TO: District of Columbia Zoning Commission

SUBJECT: Public Hearing Report for:

- 06-11Q, George Washington University Campus Plan Modification;
- 06-12Q, George Washington University First Stage PUD Modification of Significance;
- 06-11R, Further Processing for Thurston Hall; and
- 01-17E, 1959 E Street, NW Modification of Significance.

Temporary Relocation of Student Beds Thurston Hall 2020 – 2022

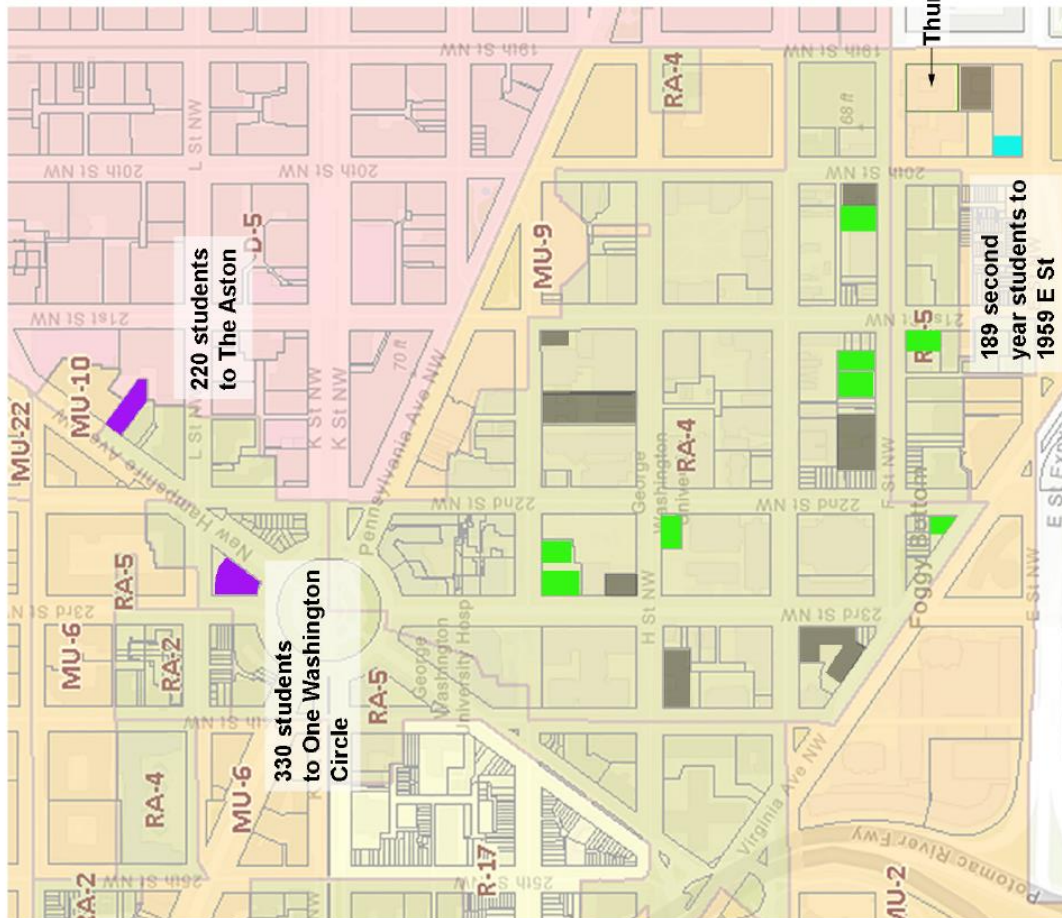
GWU requests amendments to conditions of two PUDs and the campus plan in order to facilitate the movement of students resulting from the renovation of Thurston Hall, a 1,080-bed dorm for first-year students. During the two-year renovation, the students that would have been housed in Thurston will instead be housed in other dorms on campus. Keeping first-year students on campus would be in conformance with the campus plan. However, the movement of first-year students would displace other students to residential locations where they are currently not permitted to live, per PUD/campus plan conditions. Some sophomores would live at 1959 E Street, NW, and some juniors and seniors would live at 1 Washington Circle and 1129 New Hampshire Avenue (The Aston). Law and graduate students currently at the Aston would find housing on the open market. OP requested that the applicant provide a map showing the exact dorms where students from Thurston Hall would be housed. Please see that image on the next page.

The head count of 1,080 students would be matched by the following accommodations, relocations and enrollment reductions:

198 existing surplus on-campus beds
+ 330 beds in One Washington Circle
+ 220 beds in The Aston
+ 200 fewer students through enrollment reductions in Fall 2019 and Fall 2020
+ 132 fewer students through either increased study abroad or additional enrollment reductions
<hr/>
= 1,080

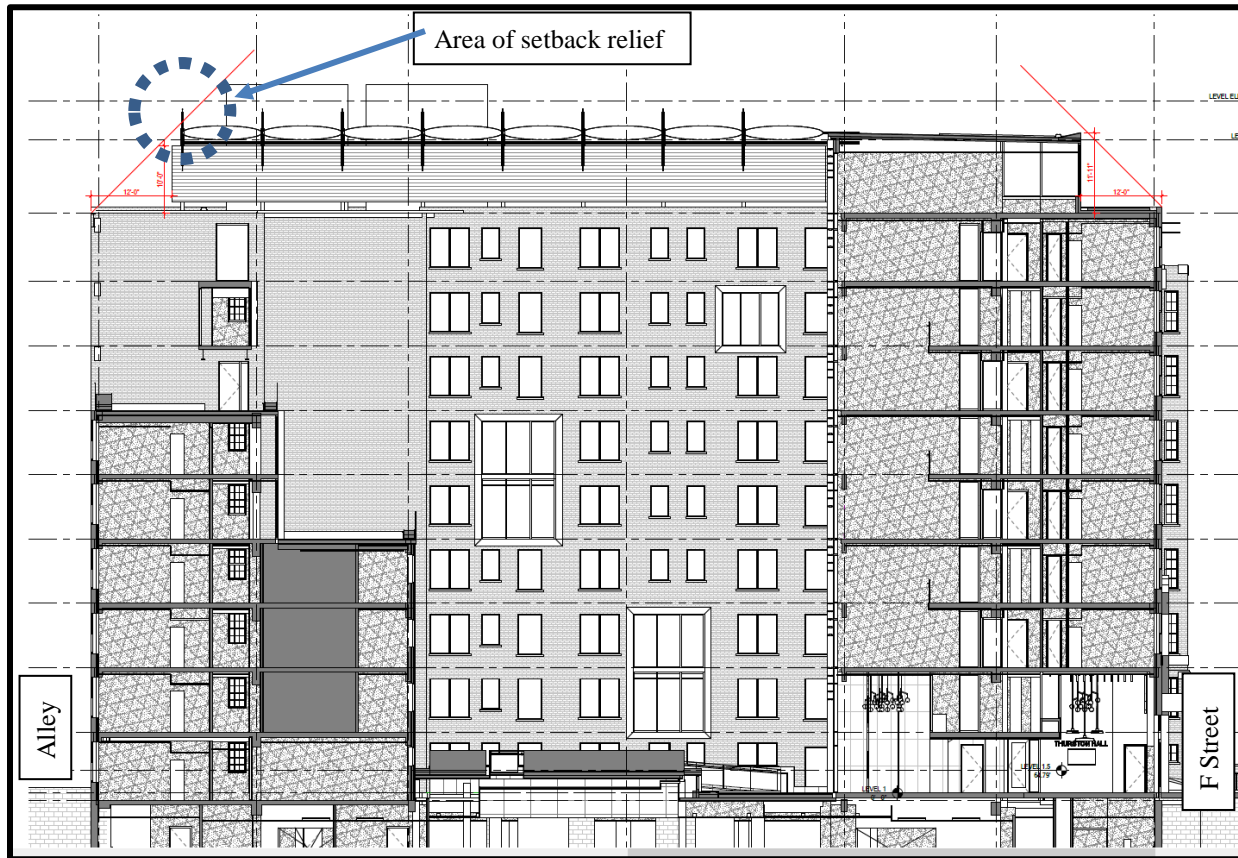
1. Lot Occupancy (G § 304, relief pursuant to G § 1200, 73.4% existing, 80% permitted, 84% proposed);
2. Penthouse Setback – Canopy Supportive Structure (C § 1502.1(b), relief pursuant to C § 1504, 1-to-1 setback required, less than 1-to-1 provided for the support structure of the canopy at the south side of the building);
3. Mechanical Equipment Screen Wall Height (C §§ 1500.8 and 1500.9; relief pursuant to C § 1504; Screen walls must match height of the mechanical equipment; Cooling towers to exceed height of surrounding screen wall).

The existing lot occupancy of 73.4% would be increased only through the construction of the canopy over the internal courtyard; The structure of the overall building would not be increased in size. The special exception can be granted if the relief would be in harmony with the intent of the MU zone and the Regulations and would not adversely affect neighboring property. In this case, the canopy would increase the utility of the interior courtyard space for the students who live in the building. Because the footprint of the building would not expand, there would be no impacts from the technical increase in lot occupancy. At the roof level, the canopy would be similar in size and massing to a potential penthouse on a building that did not have a courtyard. It should not be highly visible from the ground or from adjacent buildings.

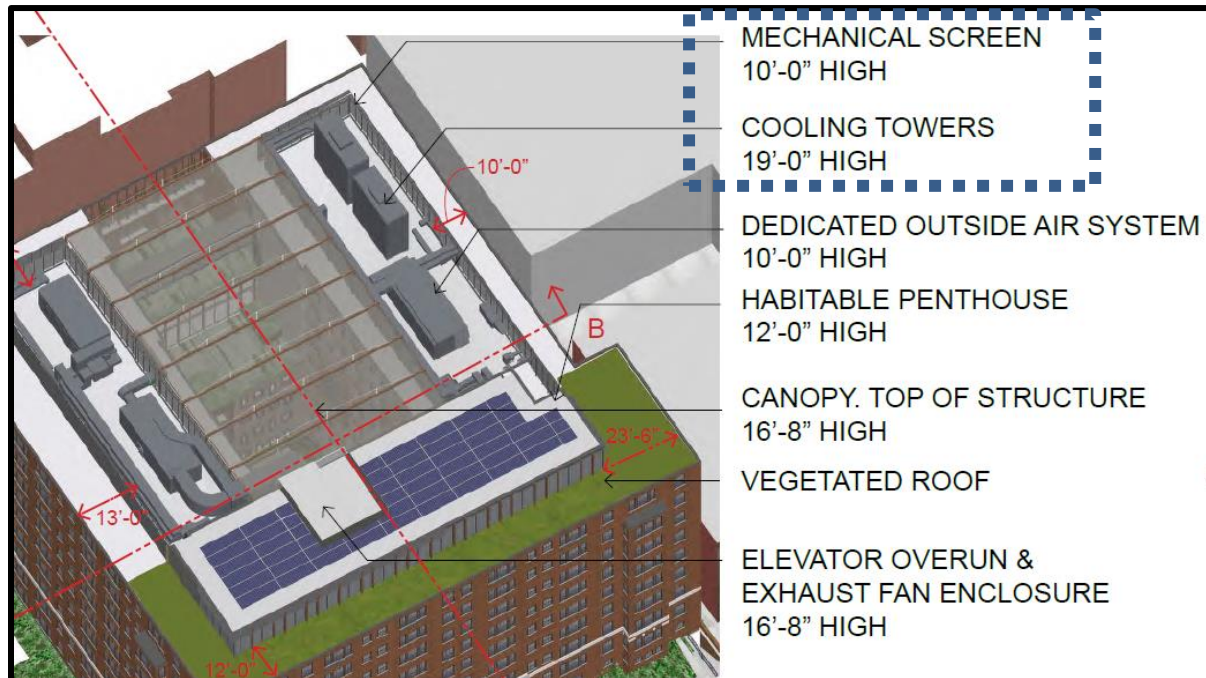
The structure supporting the canopy would not meet the required one-to-one setback from the south building wall. Please refer to the image below, which was excerpted from Case #06-11R, Exhibit 13F1, Sheet 5.

Also, the cooling towers, to be located on the southwest part of the building, would be 19 feet tall. The towers themselves meet the one-to-one setback requirement, but 19 foot tall screening walls, which must allow for air flow around the towers, would not meet the setback. The applicant has instead proposed to surround the towers with 10-foot tall screen walls, the same height as those walls screening other mechanical equipment on the roof. The 10-foot walls would meet the setback requirement, but because they would not be the same height as the cooling towers, the applicant has requested relief from C §§ 1500.8 and 1500.9. The text of those sections is below. For a rendering of the towers and the screen wall, see the image on the next page, excerpted from Case #06-11R, Exhibit 13F1, Sheet 5.

Strict application of the requirements could be interpreted to require a screen wall of 19 feet in height around all mechanical equipment at the penthouse level. Providing a single height for penthouse screening, that conceals all equipment except for the top portions of the cooling towers, would be more reasonable and would better meet the intent of this chapter by minimizing overall visibility. Regarding the penthouse structure, its slight intrusion into the 1-to-1 setback area would not be readily noticeable, especially given its location facing a private alley at the rear of the building. Based on the rendering at Sheet 44 of Exhibit 13F, it would appear that from the ground the canopy structure would not be visible at all. The location of the canopy, close to the south wall but still meeting the 1-to-1 setback for the canopy itself, would allow for maximum protection from the elements for the central courtyard, providing for the courtyard's use in three seasons out of the year.

The lower height of the screen walls would result in an overall less visible rooftop structure. The canopy support structure would slightly intrude into the 1-to-1 setback area, but would not be highly visible, if at all, from most vantage points. Neither the screen walls nor the canopy structure would appear to be extensions of the building wall.

Providing a single height for penthouse screening, that conceals all equipment except for the top portions of the cooling towers, would minimize overall visibility by providing a single 10-foot tall screen wall, rather than a 19-foot tall screen wall. The slight intrusion of the canopy structure into the 1-to-1 setback area should have no material impact in the degree of visibility of the roof structure.

The cooling towers require adequate air circulation space around them and providing 19-foot tall walls that provide air circulation would result in an intrusion into the 1-to-1 setback at the southwest corner of the building. The proposed 10 foot walls meet the setback requirement and match the height of the other rooftop screening walls. The location of the cooling towers themselves are limited to the periphery of the site given the design of the building with a large central courtyard.

The location of the canopy is governed by the desire to provide a useable, protected courtyard below. The design of the canopy itself has been pulled back from the south property line following feedback from the Commission of Fine Arts; The supporting structure, however, would still slightly intrude beyond the setback plane.

The cooling towers themselves would meet the required setbacks. 19-foot tall walls around the cooling towers, however, would not meet the setbacks. The 10-foot walls both meet the setback and provide some amount of screening for the equipment.

The intent and purpose of this chapter would not be materially impaired by the proposed structures. The lower screening walls would further the goal of less visibility for rooftop structures, and the very small incursion by the canopy structure into the setback area would not be noticeable by viewers from the ground or in adjacent buildings.
